June 30, 2015

Reference No. 1214280022-018-L-Rev0-11000

**RESPONSE TO MINISTRY OF ENERGY AND MINES MEMORANDUM DATED FEBRUARY 3, 2015
REGARDING THE BEAVERDELL TAILINGS FACILITIES**

Chart 1: Pond 4 Gradations for Filter Compatibility Comparison

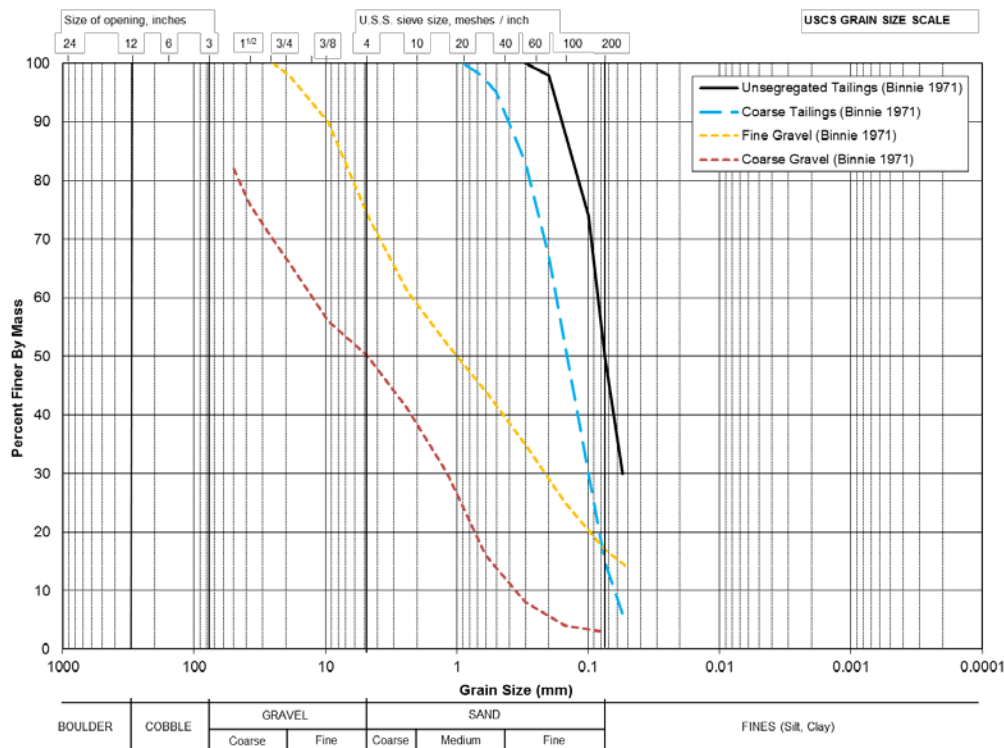
Charts 1, 2, 3, and 4 show the gradations of the sand and gravel material that were used to construct the dam section, the coarse tailings wedge (beach) developed to filter slimes, and the unsegregated tailings or slimes for each of Ponds 4, 5, 6, and 7, based on gradations of samples taken (Binnie 1971, 1980a, 1983, 1988a).

Gradations of the coarse tailings (beach) are filter compatible with the gradations of the slimes for samples taken in Ponds 4, 5, 6, and 7.

Chart 4: Pond 7 Foundation/Dam Section Gradations and Pond 6 Tailings Gradations for Filter Compatibility Comparison

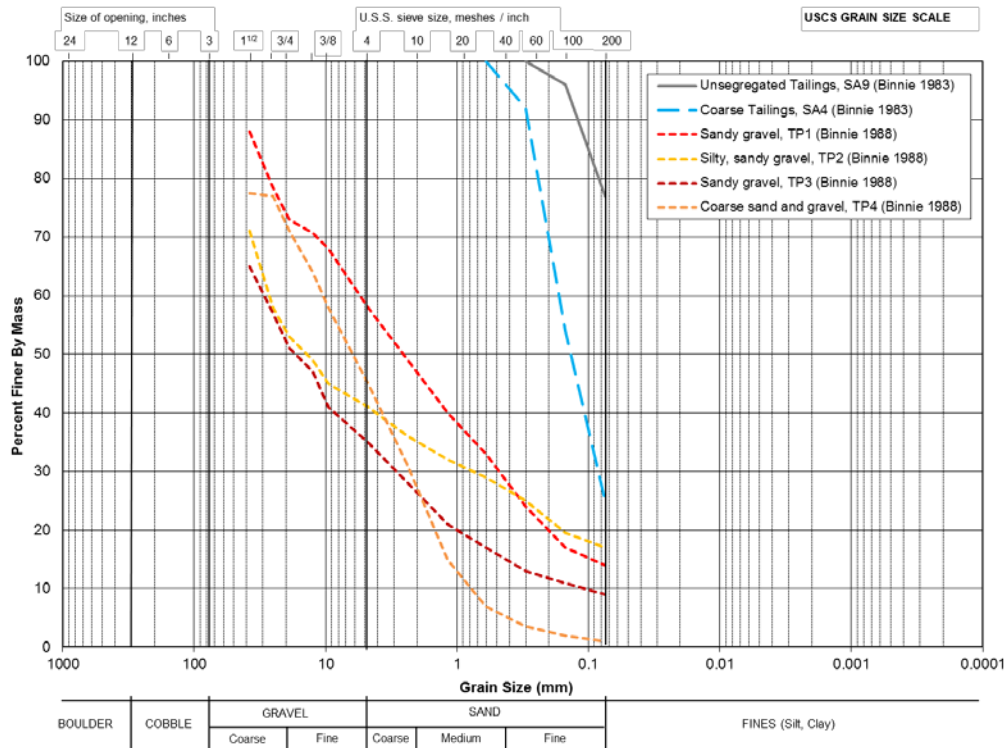
Gradations of the coarse tailings (beach) are filter compatible with the gradations of the sand and gravel dam for all samples taken except for the coarse sand and gravel from test pit (TP) 4 in Pond 7. However, Pond 7 was never filled with tailings, so this gap represents a low risk for piping failure.
